Completeness & Macro-Level Review

Detailed Micro-Level Review

Figure 2 - Delta-Z ortho image of tile C16767.

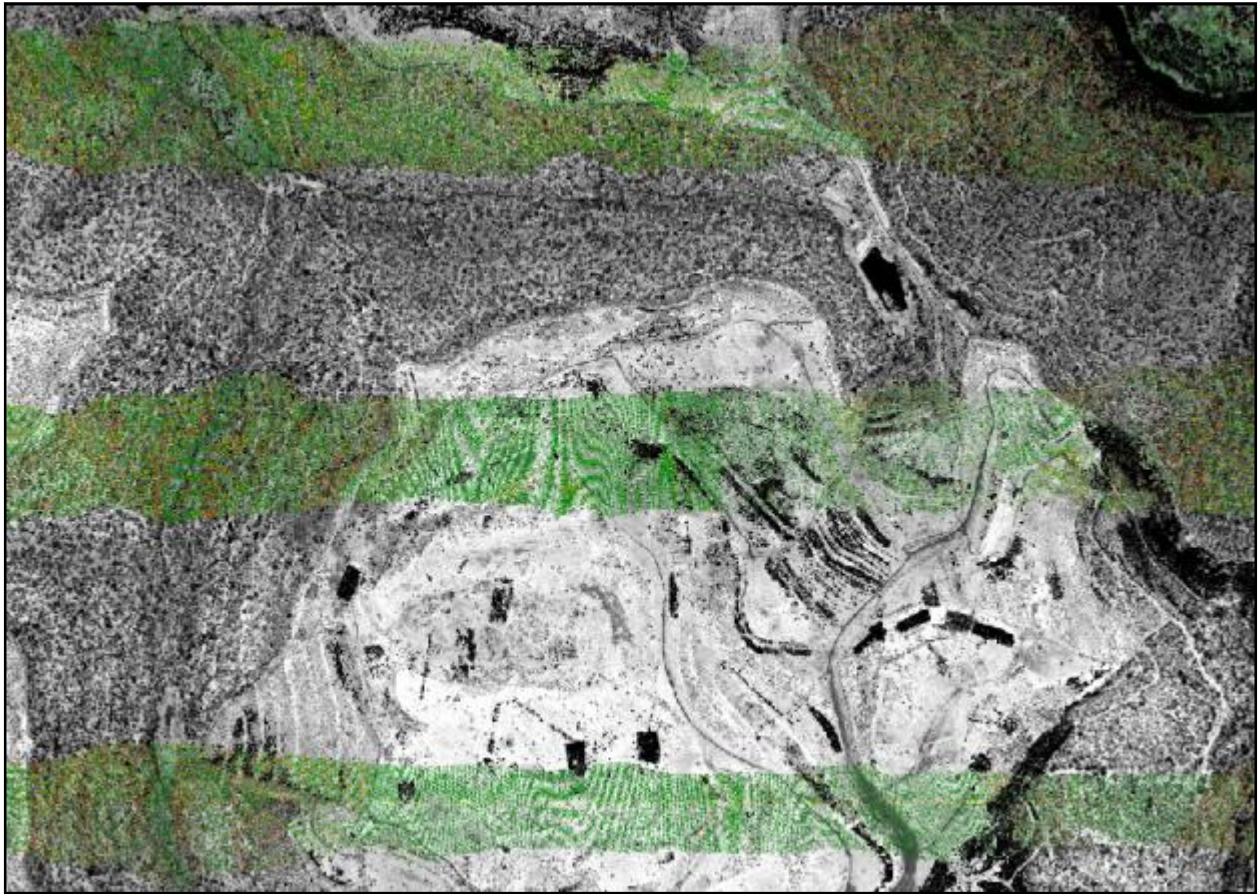
In the image above, the pixel size was 2 meters and the error gradient was 0.15 meters, meaning the green pixels have an error value of less than 0.15 meters, the yellow pixels have an error of 0.15-0.30 meters, and the red pixels have an error of greater than 0.30 meters. Due to the extremely high relief in the project area many of the pixels showing large elevation errors are not a reliable measure of possible calibration issues. In this situation a higher priority was placed on the low-relief areas, such as the areas around the river and along the roads. The image above is a good example of the quality of the Third Delivery dataset, where a low delta-Z error is prevalent in the low-relief areas around the river and along the roads.

Figure 4 - Aggressive Classification in tile C18593. The purple points are ground and yellow are non-ground.

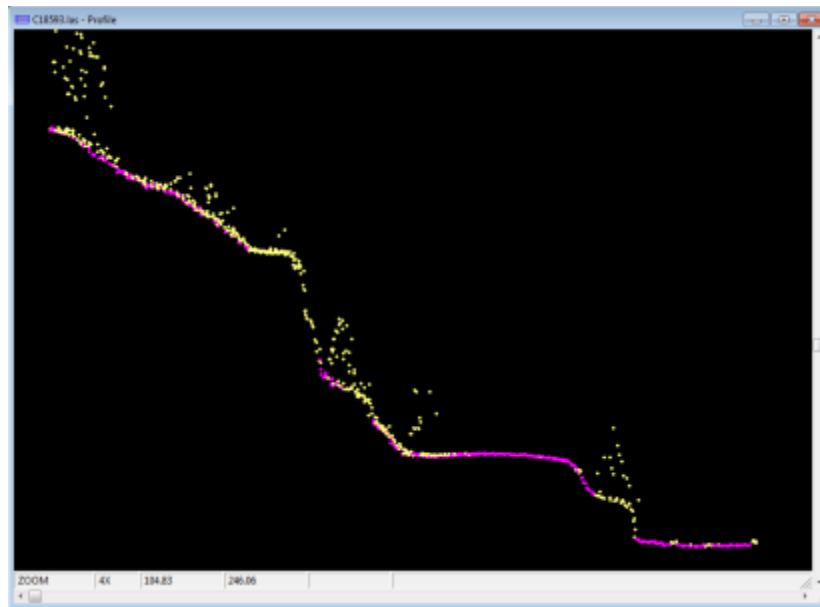
One of the limitations of LiDAR processing algorithms is the ability to differentiate between ground points and vegetation along the edge of a hill or ridge. Since the ground classification algorithm relies on point-to-point distance and angle to determine if a point is ground or non-ground, ground points at the apex of a hill or ridge can be “aggressively” classified out of the ground. Figure 4 below shows ground points in tile C18593 that have been aggressively classified.

Figure 5 - Tile C20264 showing vegetation artifacts along the side of the hill

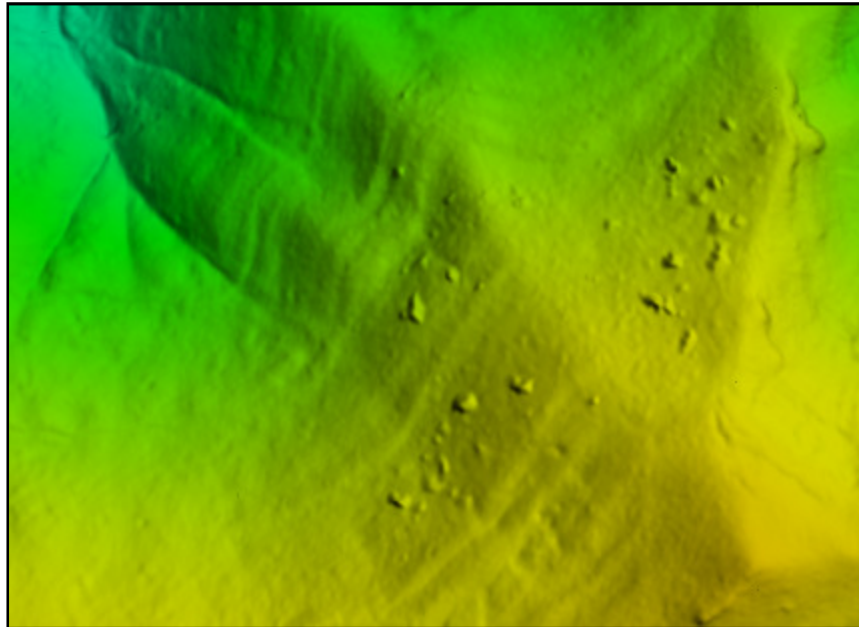
Artifacts are vegetation, buildings, or bridges that are improperly classified as ground points. Most of the non-ground features are classified by the automated ground algorithms in the LiDAR processing software, but it is necessary to manually review the data and remove any remaining non-ground points from the ground surface. Normally a tolerance of 5% of the vegetation artifacts is allowed as manual classification is sometimes subjective and different analysts will interpret the surface differently. Also, bridges with a distinct deck above the ground are normally removed to allow hydro to flow through during flood modeling. Culverts are not normally removed and will be discussed later in this document.

Figure 8 - Tile C18592 showing a divot that causes misclassification of the ground surface

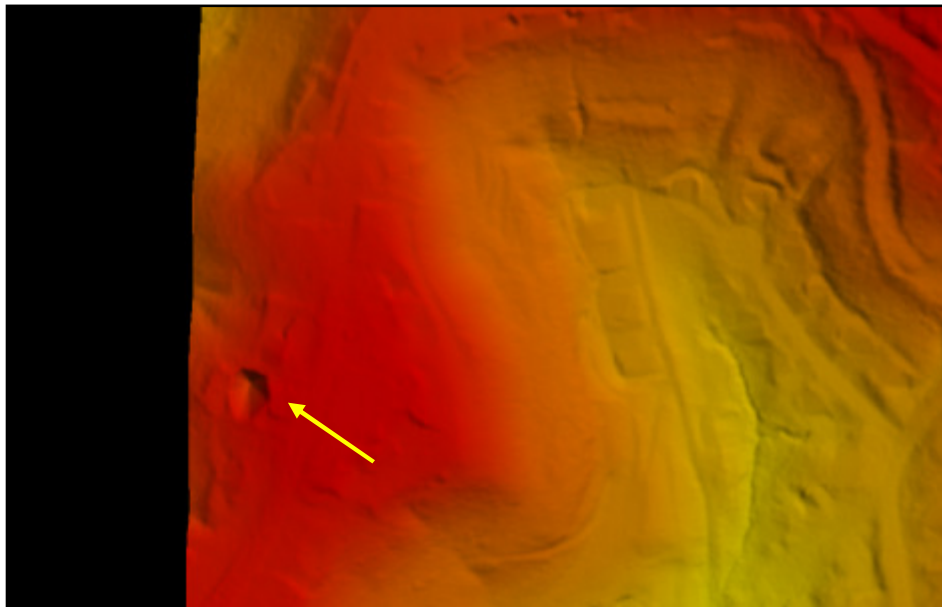
Divots are points that fall far below the expected ground surface. They can occur because of a timing error in the LiDAR sensor or near buildings where the LiDAR pulse is distorted by glass. Because the LiDAR processing software looks for the lowest point near the previously classified ground, the divots are marked as ground and the true ground is treated as non-ground.

Figure 9 - Tile C18492 showing ground points removed from a culvert

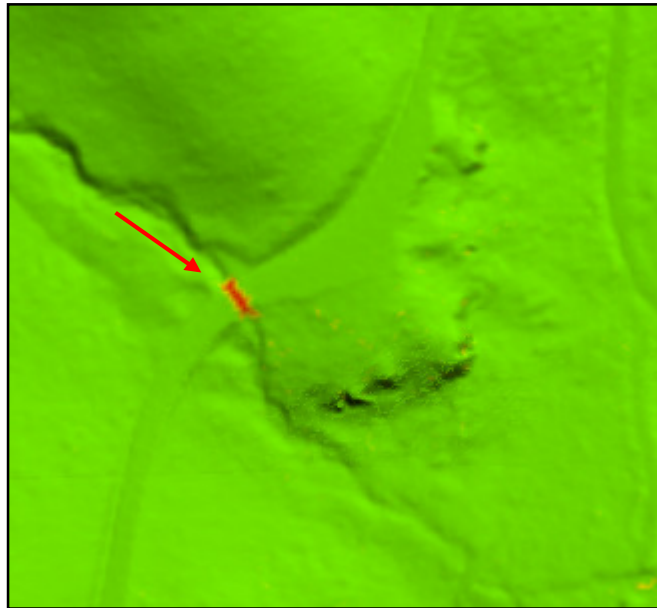
A culvert is a feature that allows hydro to flow underneath a road, but unlike a bridge, does not have a man-made deck above the ground surface. A culvert can be differentiated from a bridge because it has visible ground between the road and the hydro surface. As mentioned above in the Artifacts section, culverts should be left in the ground.

Figure 10 - Vegetation artifacts along the edge of a tile.

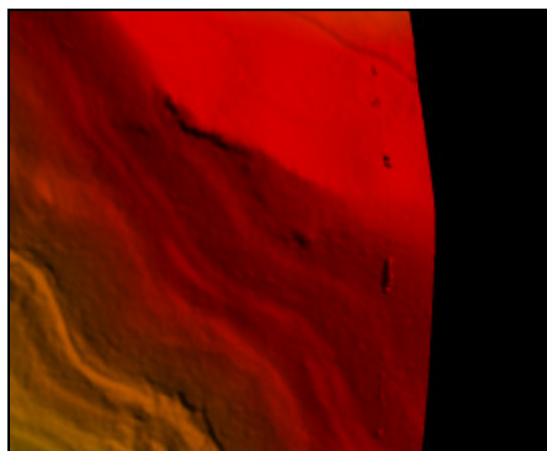
Overlap in tiles resulted in inconsistent editing along the tile edges. Many tiles contained vegetation and structure artifacts in these overlapping areas. Figure 10 shows a line of artifacts that were left along the western edge in the ground density model of tile C20585.

Figure 11 - A ridge formed in the overlapping area between tiles.

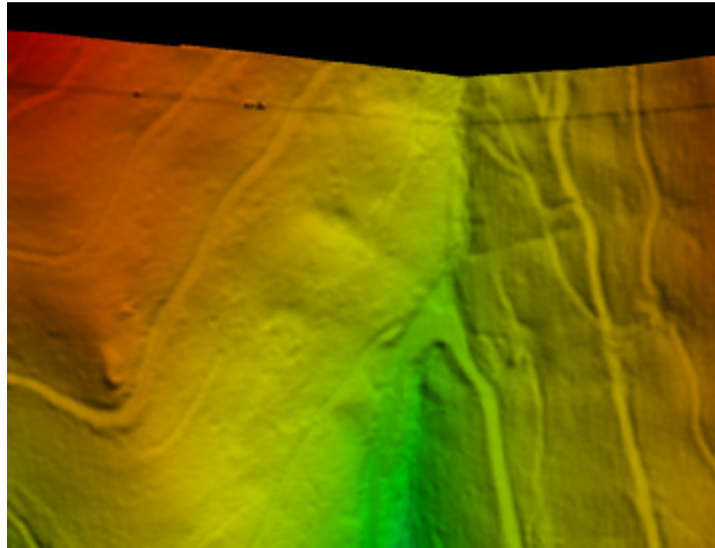
In a few cases, a ridge appeared in the overlapping areas. This signifies a change in ground elevation from one tile to the next and is likely a result of flight line offsets. Figure 11 shows a ridge in the overlapping area between tiles C20427 and C20266.

Figure 17 - Checkpoint WV3_D_39

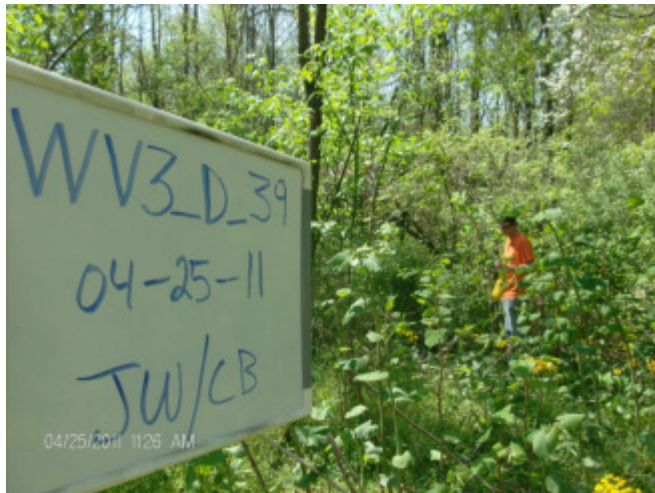
All of the removed points can be seen in the images below. These points were removed from the RMSE due to their located in heavily vegetated areas. The difference between the checkpoint elevations and the LiDAR elevations for the removed points were all higher than 2.5 meters, which suggests a possible survey issue on those specific points or an error in ground classification.
